Workshop Manual

SUPPLEMENT

3000GT '98

Pub. No. PWUE9119-G

MIXTURE ADJUSTING SCREW (Variable Resistor) <Vehicles for General Export and GCC>

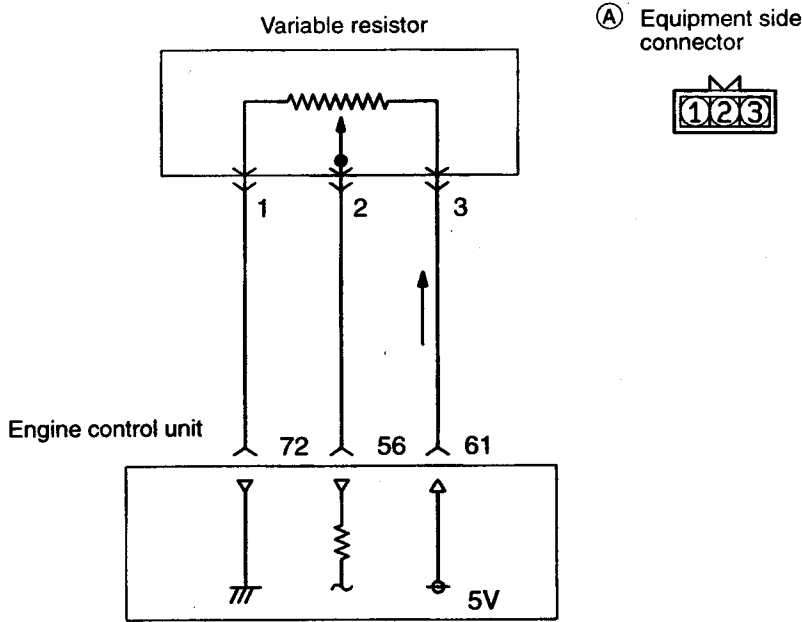
- The connector for the mixture adjusting screw (variable resistor) has been changed. The following maintenance service points which are different from previous vehicles have been established to correspond to this.

<div style="border: 1px solid black; padding: 5px; width: 30px; text-align: center; margin-bottom: 10px;">1</div> <p style="font-size: small;">(A) Harness side connector</p> <p style="text-align: right; font-size: x-small;">7FU2074</p>	<p>Measure the power supply voltage of the variable resistor.</p> <ul style="list-style-type: none"> • Connector: Disconnected • Ignition switch: ON <table border="1" style="width: 100%; margin-top: 10px;"> <tr> <td style="text-align: center;">Voltage (V)</td> </tr> <tr> <td style="text-align: center;">4.8 – 5.2</td> </tr> </table>	Voltage (V)	4.8 – 5.2	<div style="display: flex; flex-direction: column; align-items: center; justify-content: center;"> <div style="margin-bottom: 20px;"> </div> <div style="margin-bottom: 20px;"> </div> </div> <div style="display: flex; justify-content: space-around; align-items: center;"> <div style="border: 1px solid black; padding: 5px; width: 30px; text-align: center;">2</div> <div style="text-align: left; padding-left: 10px;"> <p>Repair the harness.</p> <p>(A) 3 – 61</p> </div> </div>
Voltage (V)				
4.8 – 5.2

<p>2</p>  <p>7FU2075</p>	<p>Check for continuity of the earth circuit.</p> <ul style="list-style-type: none"> • Connector: Disconnected 	<p>OK → 3</p> <p>OK → Repair the harness. (A 1 - 72)</p>
--	---	---

<p>3</p>  <p>7FU2076</p>	<p>Check for an open-circuit, or a shortcircuit to earth between the engine control unit and the variable resistor.</p> <ul style="list-style-type: none"> • Variable resistor connector: Disconnected • Engine control unit connector: Disconnected 	<p>OK → STOP</p> <p>OK → Repair the harness. (A 2 - 56)</p>
--	--	--
